CONTROL ROOM DESIGN REVIEW
SUMMARY REPORT
HOPE CREEK GENERATING STATION

Prepared for:
Nuclear Regulatory Commission

Prepared by
Essex Corporation for:
Public Service Electric & Gas Company

August 6, 1984

Figure B.1 Control room panel layout

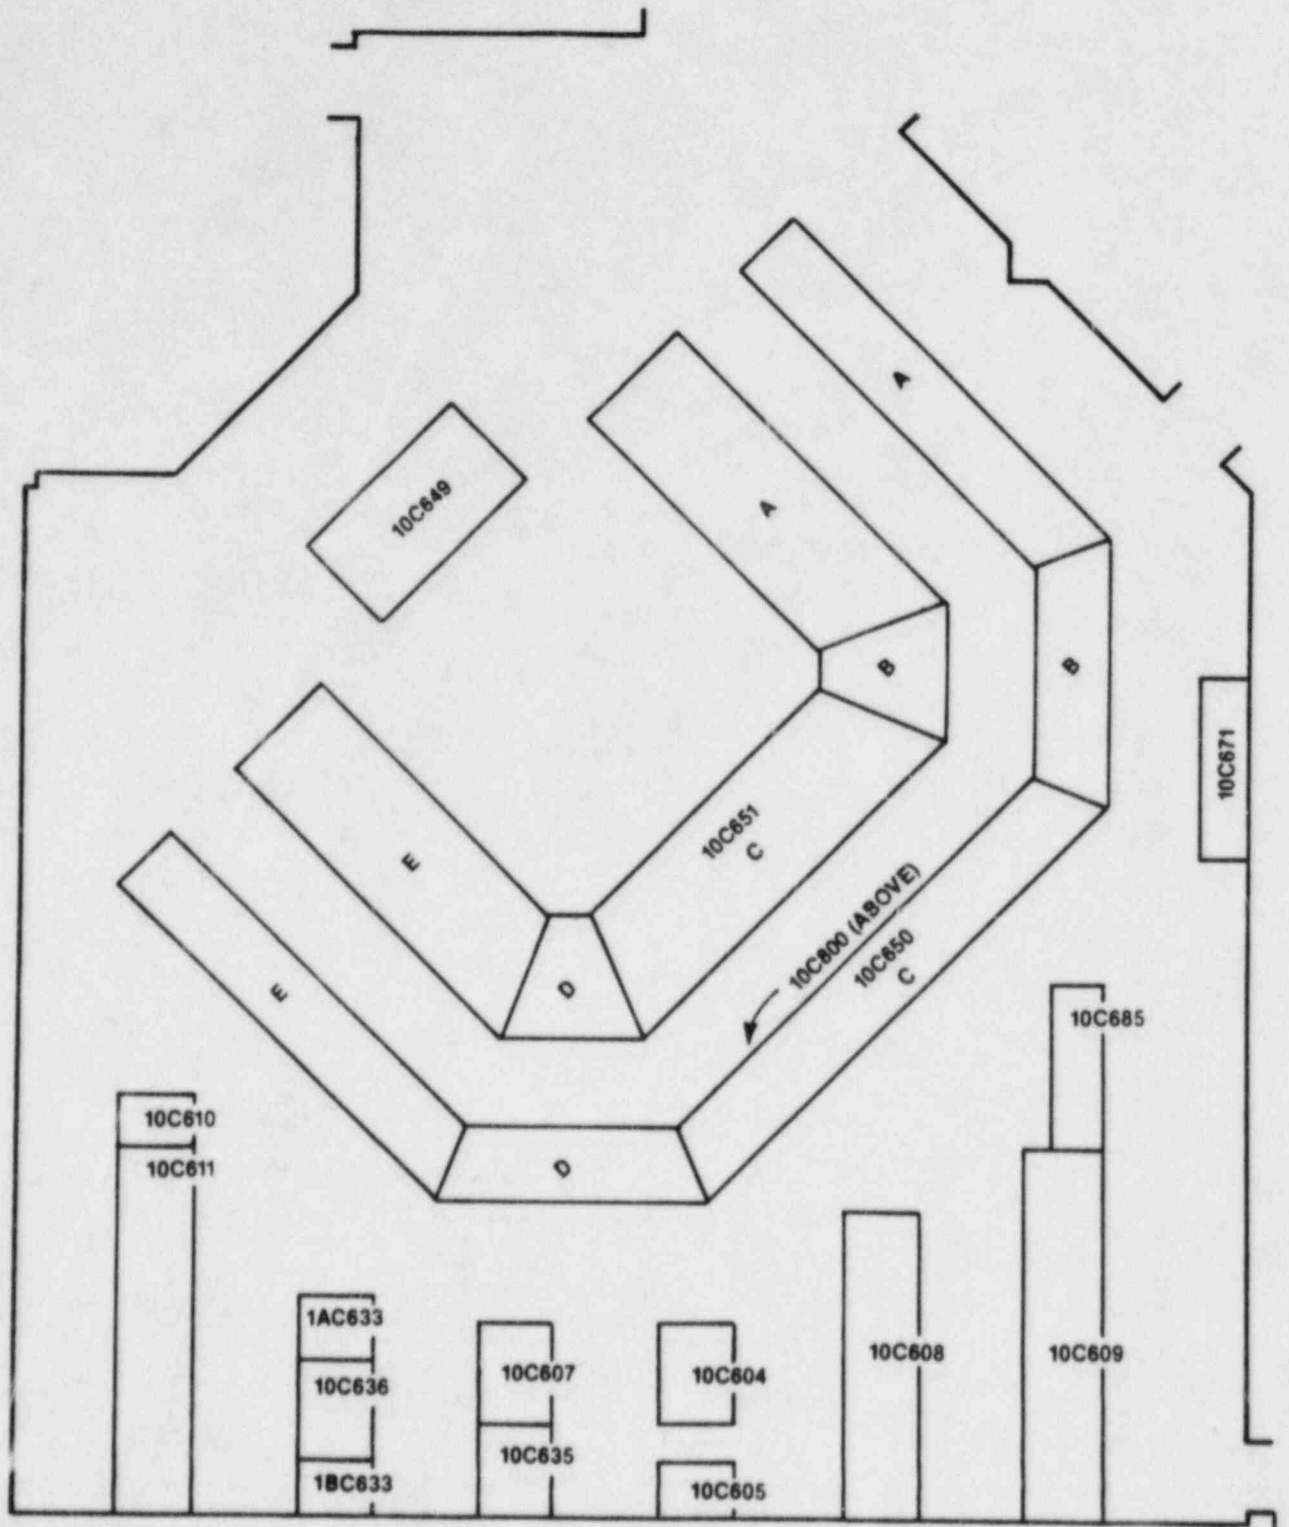
A27: The present locations of the key position labels on these RZ keylock switches do not provide clear key position information (panels Ac - Cc, Av, Ev).

A28: These vertical meters, mostly on the console sections (e.g., panel Ec), have a certain amount of parallax due to the scales, numerals, and pointers being in different planes.

A45: The RHR A and B mimics on panel Av do not show how the Jockey Pumps feed into Loop C and Loop D.

Disposition: This HED will be corrected. All keys in the control room will be notched on that side of the key which corresponds to the SAFE Or OFF position. The keys cannot be removed unless they are in the SAFE or OFF position. To avoid any operator confusion as to switch position, all existing RZ keylock "ON/OFF" nameplates will be replaced with nameplates that show only the on position.

Disposition: A correction is not planned for this HED (Category 4). The amount of parallax is small (one or two minor graduation marks). Readings to the required degree of accuracy can be obtained by the operator.
